**ISSUE:** Alterations and Signage

**APPLICANT:** City of Alexandria (Patrice McAuliffe, Agent)

**LOCATION:** 134 North Royal Street (Gadsby's Tavern)

Glass Exhibit Panels – Surrounding Ice Well at Sidewalk Level

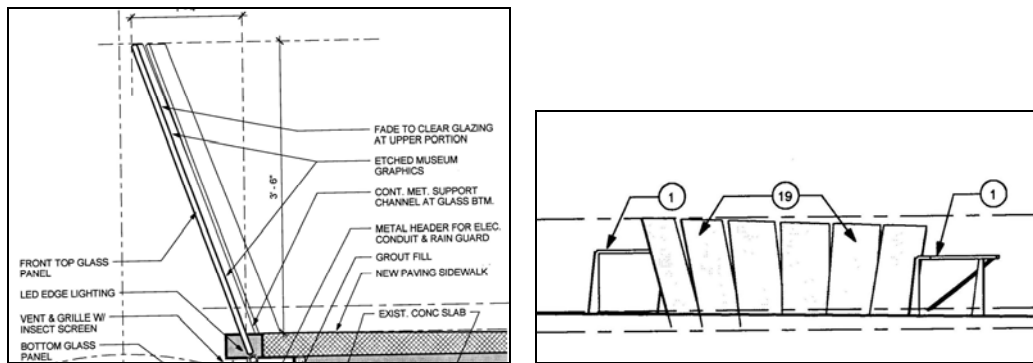
The existing metal guard rails are being replaced with separate, externally lit, glass exhibit panels fabricated in a clear safety glass. The glass display panels will be transparent, with the text and photo displays being etched into the glass. They will be supported through the use of a metal channel support system. There will not be any visible metal frames or “ribs” surrounding or within the glass panel, providing a clear view through the glass of the existing Gadsby’s Tavern wall surface. The Applicant is requesting conceptual approval for the images and text to be displayed on these panels, with the final design and historic accuracy of the text to be reviewed and approved by the City Archaeology and Historic Preservation Planning staff. The glass panels are an educational medium for the museum to convey the cultural and historical significance of the Tavern and Ice Well.

Glass Exhibit Panels – Tradesman’s Entrance

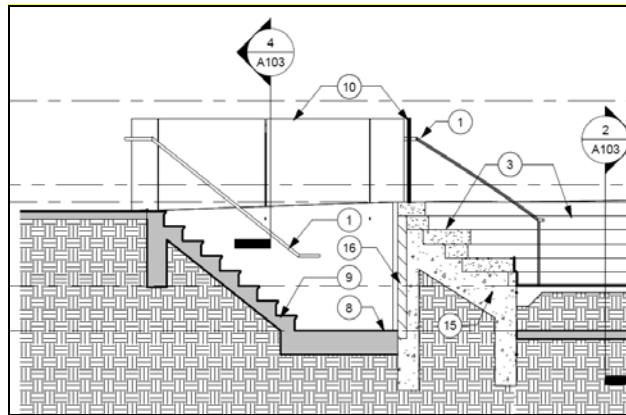
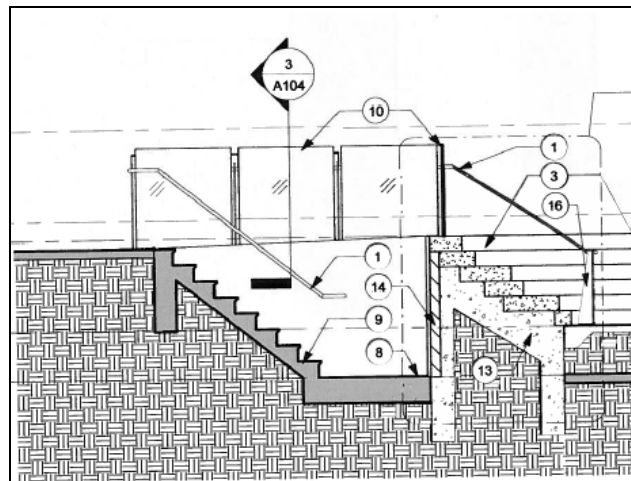
The existing metal guard rails were to be replaced with an internally lit, solid plate glass exhibit panel fabricated in a frosted safety glass.

The existing metal guard rails are being replaced with three, separate, externally lit, glass exhibit panels fabricated in a slightly frosted glass. The support detail for these panels is for its form to replicate an ice tool.

#### Lighting

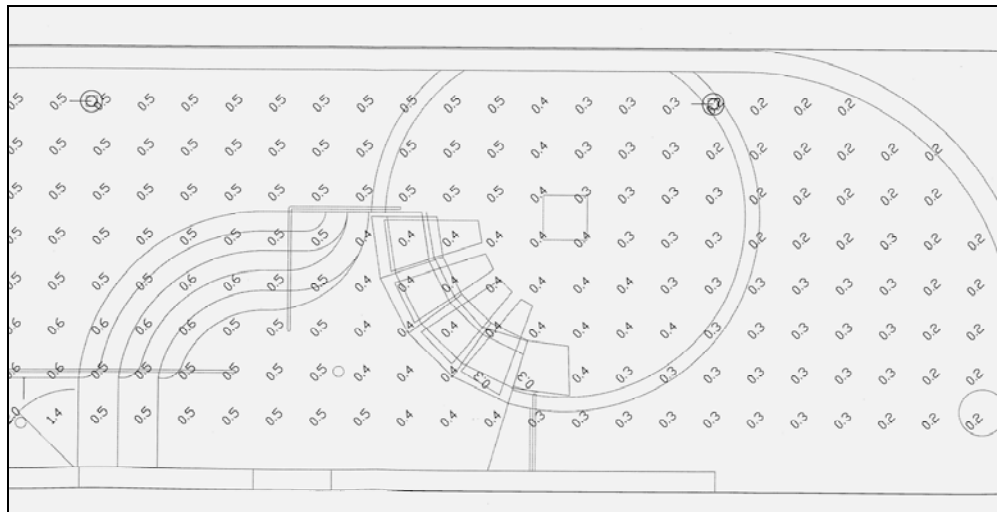
The original lighting design provided a significant amount of light spillage beyond the ice well into the surrounding public Right-of-Way (ROW). It was the recommendation of Staff to reduce the lighting levels to mitigate the projects impact on pedestrians, drivers and the adjacent community. It was recommended that the Applicant attempt to achieve illumination levels of 0.6 footcandles or below in the public ROW.

The revised lighting design has changed dramatically from the original submittal. The glass panels will be lit utilizing low level LED lights. The new photometric plan illustrates that the lighting levels will not exceed the Staff recommended 0.5 footcandles at curb edge. A substantial reduction from the original design which had illumination levels reaching 1.1 footcandles at curb edge and well over 10 footcandles over the ice well opening.

2. That the applicant and their design team work with Historic Preservation Planning staff to refine the lighting program to ensure the lighting is compatible with the site and surrounding neighborhood, prior to the project's final permit inspections;

Figure 12: Archaeology Limits of Disturbance

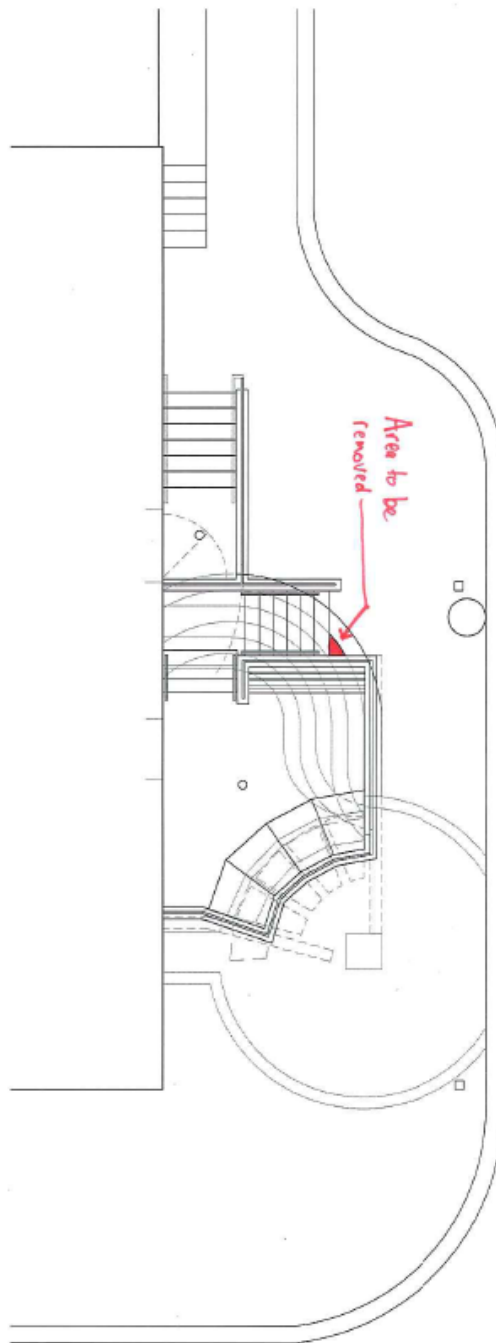
The proposed design will have very minimal impacts to undisturbed earth. The applicant has provided a drawing indicating the Limits of New Disturbance for the project (see Figure 12). The shaded area in the drawing indicates where the Applicant proposes to cut into earth that has not already been previously impacted. As shown, these areas are very minimal, and will be monitored by City Archaeology staff.

The new design will have very minimal impacts to undisturbed earth. The applicant only proposes to excavate a very small piece of earth that has not already been previously impacted. The remaining project will be fabricated on the existing site’s footprint. As shown in the recommended conditions, the City Archaeology staff proposes to monitor all phases of the project to ensure the project maintains conformance to the strict Limits of Disturbance (LOD) and footprint.

3. The applicant/developer shall call Alexandria Archaeology (703/838-4399) two weeks before the starting date of any ground disturbance so that an inspection schedule for city archaeologists can be arranged;

4. The applicant/developer shall call Alexandria Archaeology immediately (703-838-4399) if any buried structural remains (wall foundations, wells, privies, cisterns, etc.) or concentrations of artifacts are discovered during development. Work must cease in the area of the discovery until a City archaeologist comes to the site and records the finds;
